## **Addendum 78 – UN Regulation No. 79**

### **Revision 3 –Amendment 2**

### **Uniform provisions concerning the approval of vehicles with regard to steering equipment**

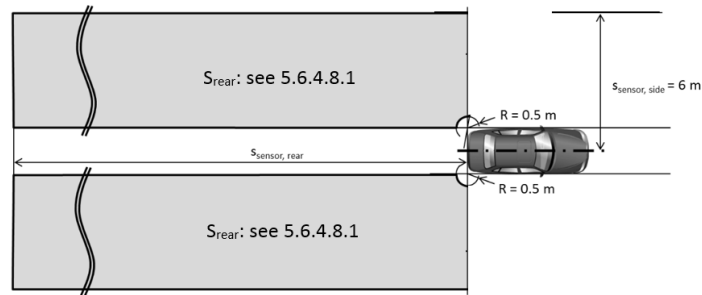
5.6.4.8.2. The vehicle system detection area on ground level shall be at minimum as shown in the figure below.
